**MONTGOMERY COUNTY HISTORIC PRESERVATION COMMISSION**  
**STAFF REPORT**

<b>Address:</b>	4717 Drummond Ave., Chevy Chase	<b>Meeting Date:</b>	05/24/17
<b>Resource:</b>	Master Plan Site Susan B. Chase House	<b>Report Date:</b>	05/17/17
<b>Applicant:</b>	Joshua Leifer & Elizabeth Brenner-Leifer	<b>Public Notice:</b>	05/10/17
<b>Review:</b>	HAWP	<b>Tax Credit:</b>	n/a
<b>Case Number:</b>	37/160-17A	<b>Staff:</b>	Dan Bruechert
<b>Proposal:</b>	Patio Installation

1 Section of Side Terraces and Steps  
Scale: 1/2" = 1'-0"

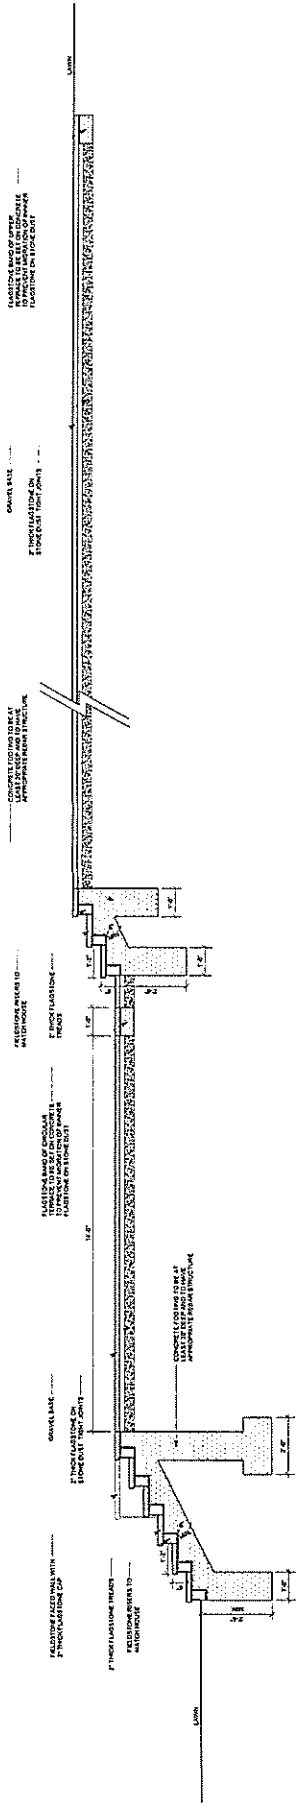
The largest of the proposed changes is the two-tiered patio to be installed to the right of the historic house. The tier closest to the front of the house will align with the front of the porch and is approximately 10' × 38' 5" (ten feet by thirty-five feet, five inches) and will be constructed using rectangular flagstones with a 12" (twelve inch) border. This section of the patio will be accessed from the side of the front porch from a new set of wood stairs that match the appearance of the front entry stairs. The lower section of patio is accessed down three masonry steps to an 8' (eight foot) radius circular patio constructed in flagstones that match the upper section. The lower section is supported at the rear by a new 3' (three foot) tall retaining wall that will be faced in fieldstone matching the house foundation.

The upper section of the patio fits into the landscape and will be, at most, a few inches above grade. And while the design is cohesive with the lower section of the patio, Staff feels that bringing the front edge of the proposed patio even with the front porch foundation will change the character of this historically landscaped section of the property contravening Standards 2 and 9. Staff feels that this can be mitigated by reducing the paved portion of the patio so that it extends no further forward than the front wall plane of the historic house. This change would preserve an approximately 9' × 10' (nine foot by 10 foot) section of landscaping and would lessen the visual impact of the expanse of new hardscape and can be supported under Chapter 24A-8(b)(2) and Standard 9. The applicants have agreed to this change and will meet the condition recommended for approval.

1. The upper section of the patio may not project forward of the front wall plane of the house.
